USB Type-C ENGINEERING CHANGE NOTICE

Title: Plug Dimensions Update

Applied to: USB Type-C Spec R2.2 – October 2022

(a). For Figure 3-3 Section A-A in Section 3.2.1

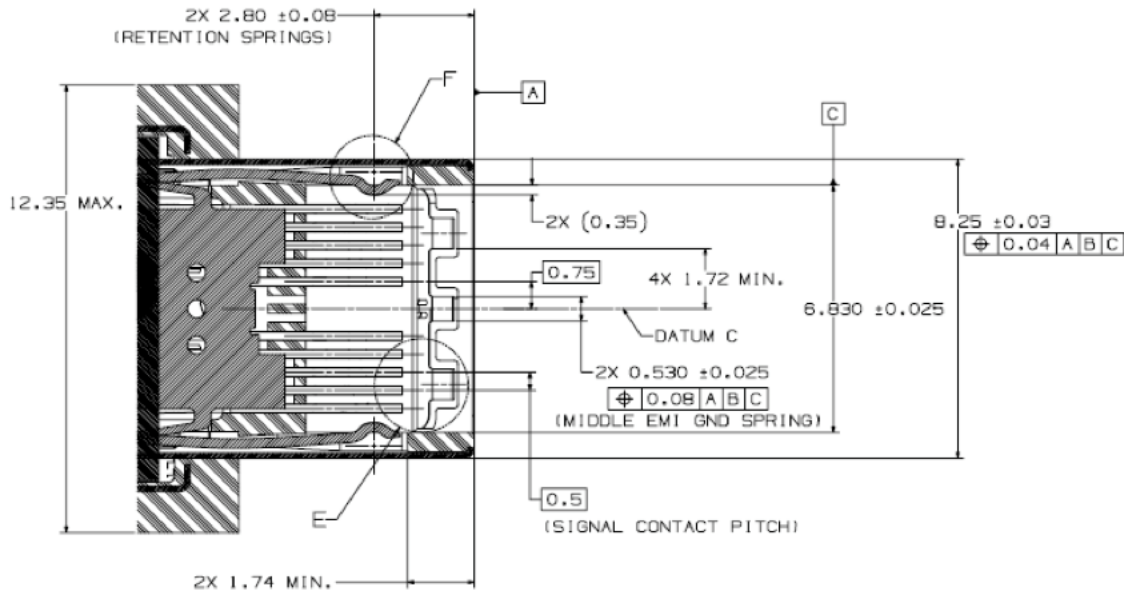
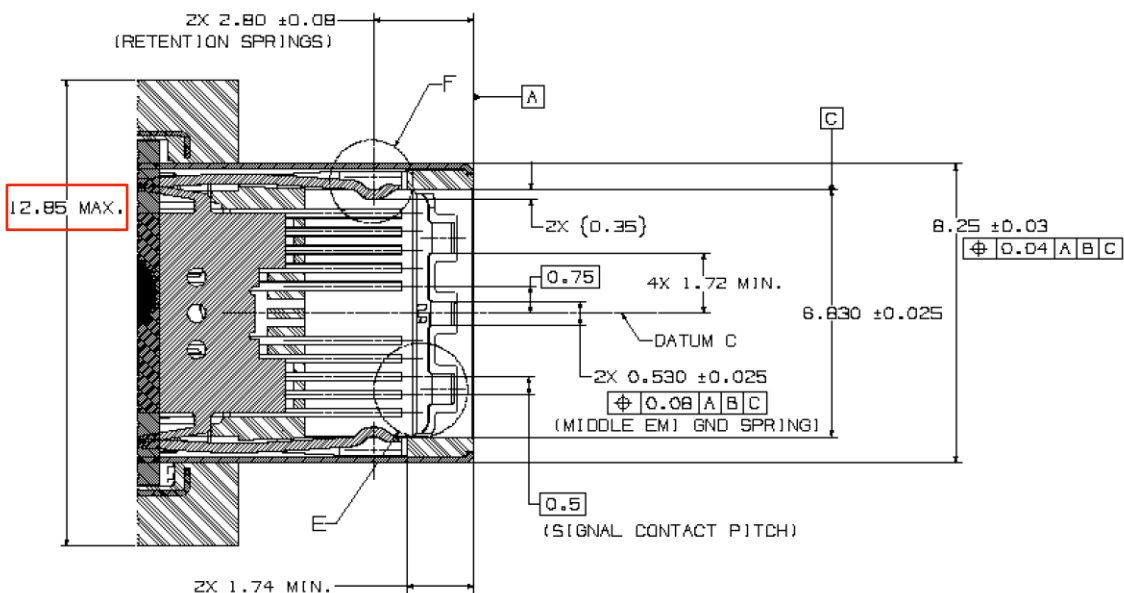
Plug overmold width and height for USB Type C cable assemblies. Recommended minimum port spacing is increased to match overmold increase. Cable mating considerations are clarified to include shape of overmold.

From Text:

To Text:

(b). For Figure 3-3 Section C-C in Section 3.2.1

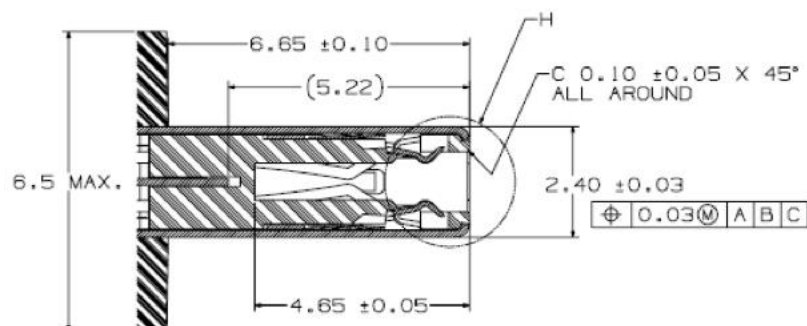
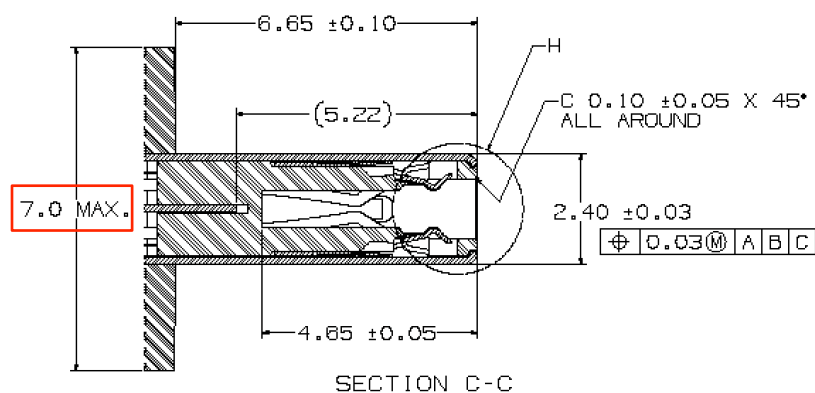
From Text:

To Text:

(c). For Figure 3-11 Section A-A in Section 3.2.1

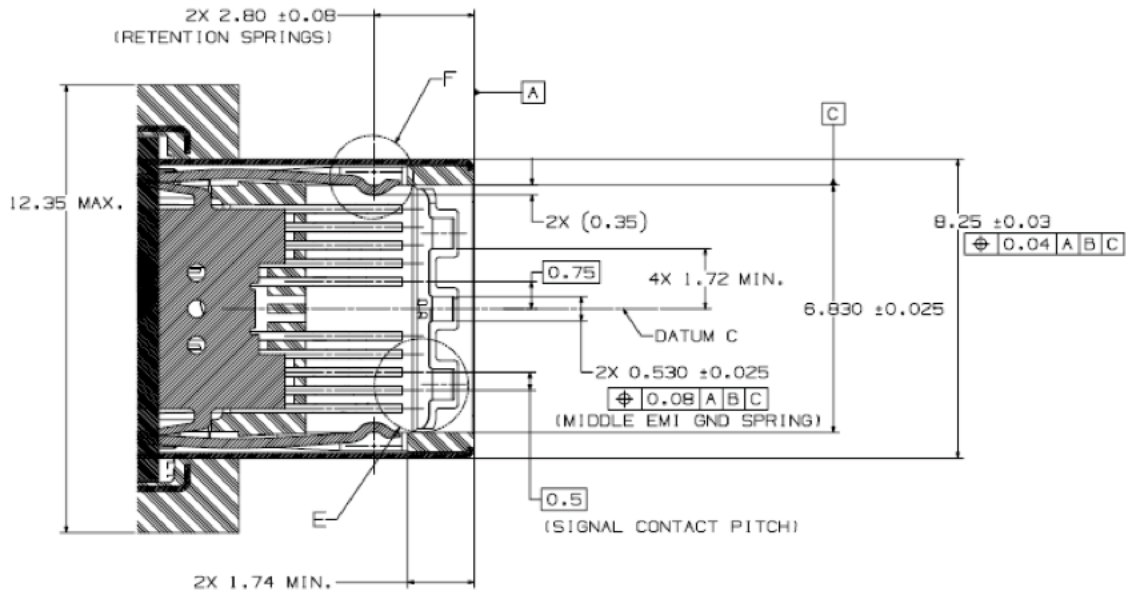
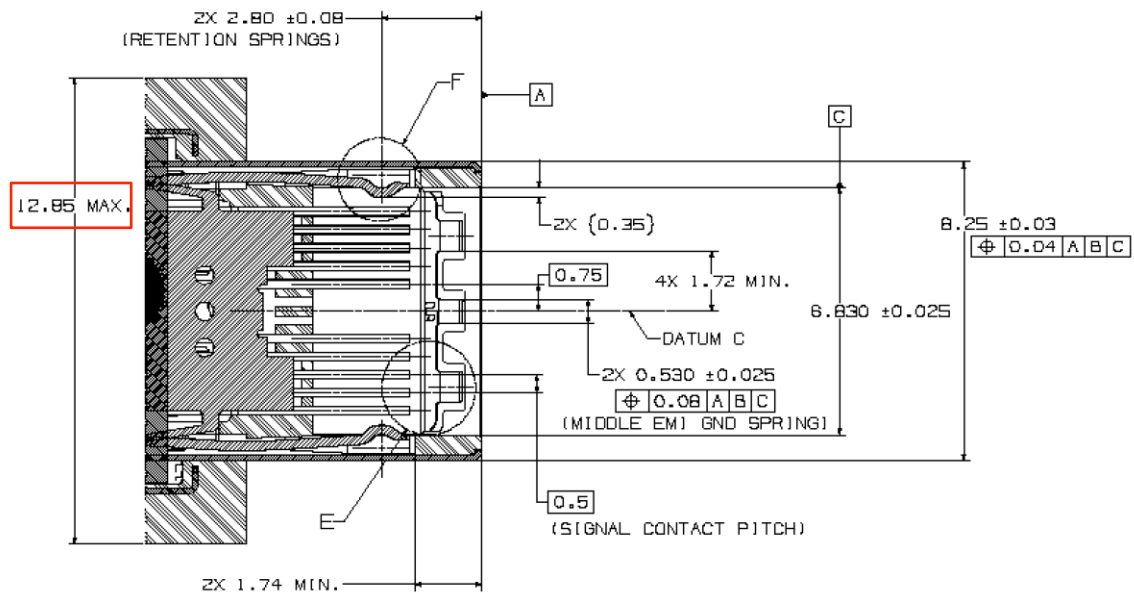
From Text:

To Text:

(d). For Figure 3-11 Section C-C in Section 3.2.1

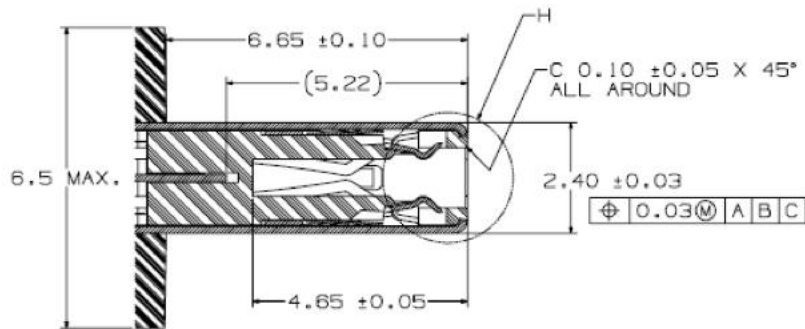
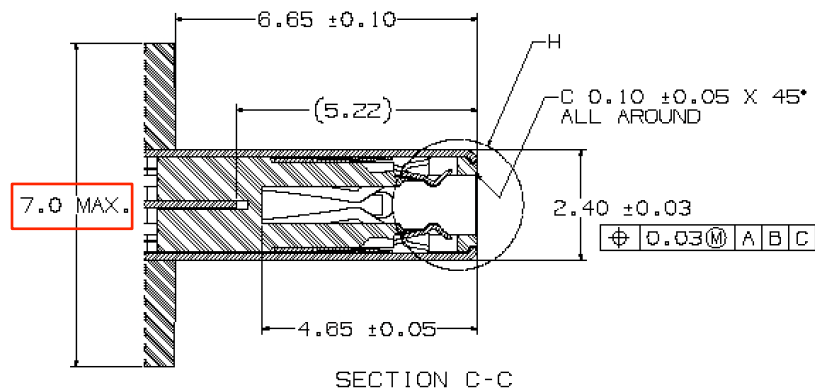
From Text:

To Text:

(e). For Figure 3-79 in Section 3.10.2

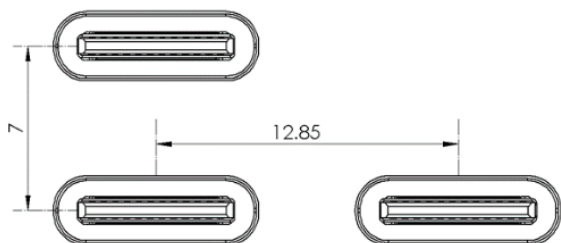
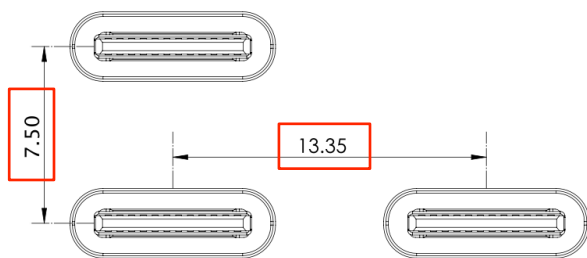
From Text:

To Text:

(g). Section 3.10.3, Figure 3-80

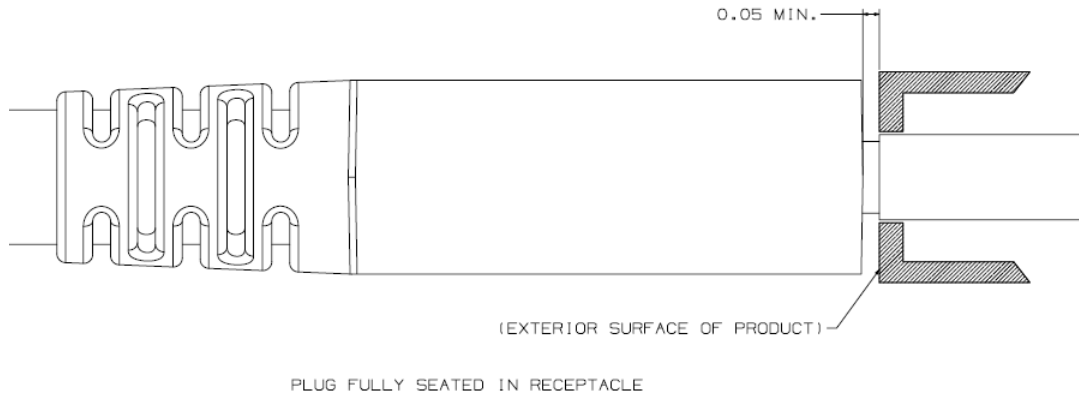
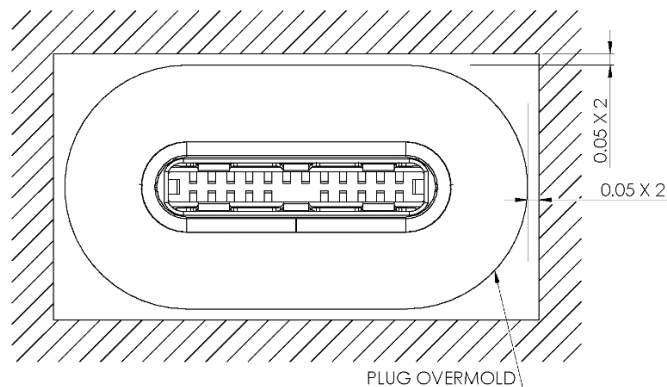
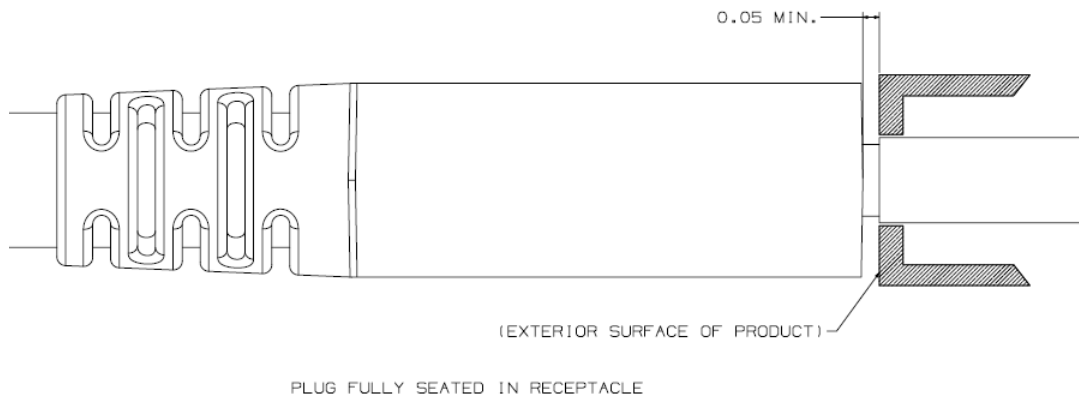
The receptacle mounting location, exterior product surfaces, cable overmold, and plug mating length need to be considered to ensure the USB Type-C plug is allowed to fully engage the USB Type-C receptacle. Figure 3-80 illustrates the recommended minimum plug overmold clearance to allow the cable plug to fully seat in the product receptacle.

The receptacle mounting location, exterior product surfaces, cable overmold, and plug mating length need to be considered to ensure the USB Type-C plug is allowed to fully engage the USB Type-C receptacle. Figure 3-80 illustrates the recommended minimum plug overmold clearance to **avoid interference between the plug overmold and enclosure opening, allowing** the cable plug to fully seat in the product receptacle.
